LuK Service Info

Part Nr. 135 0221 10 / 335 0150 10

Manufacturer: LANDINI – 16000, 16550, 17550
 MASSEY FERGUSON – 2000 & 3000 Series –
 Non Dynashift

Info: 635 1410 09 replaces / ersetzt /
 remplace / sustituye a /
 sostituisce 135 0221 10 & 335 0150 10

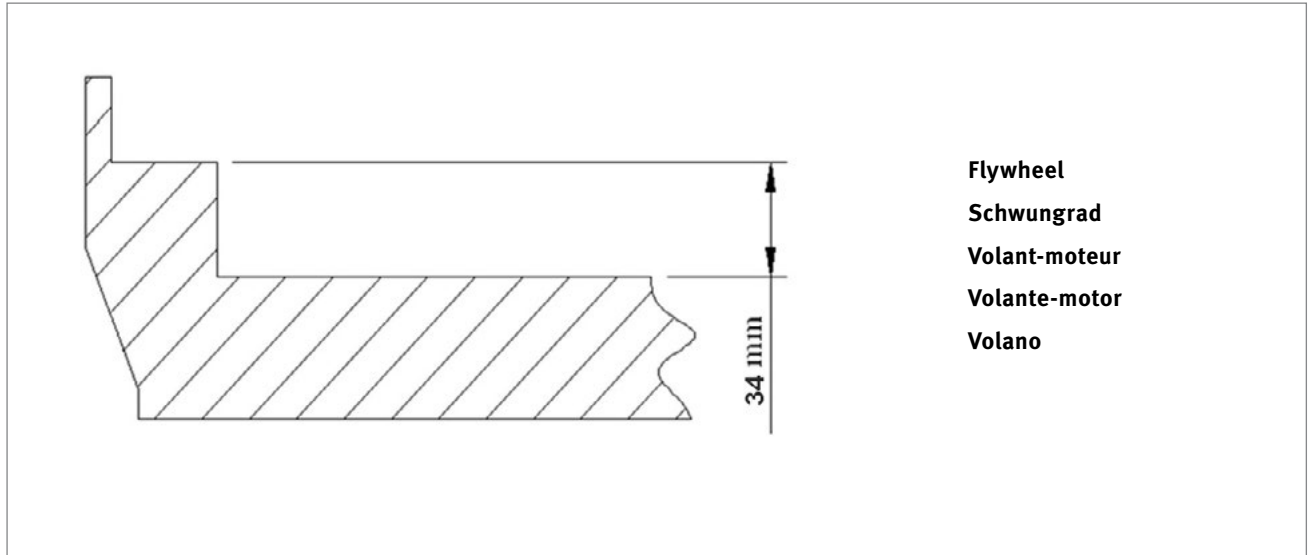
Not interchangeable with Valeo. Flywheel pot depth must be 34mm. Do not fit shims.

635 1410 09
635 1410 10 = 635 1410 09 + 500 0601 30
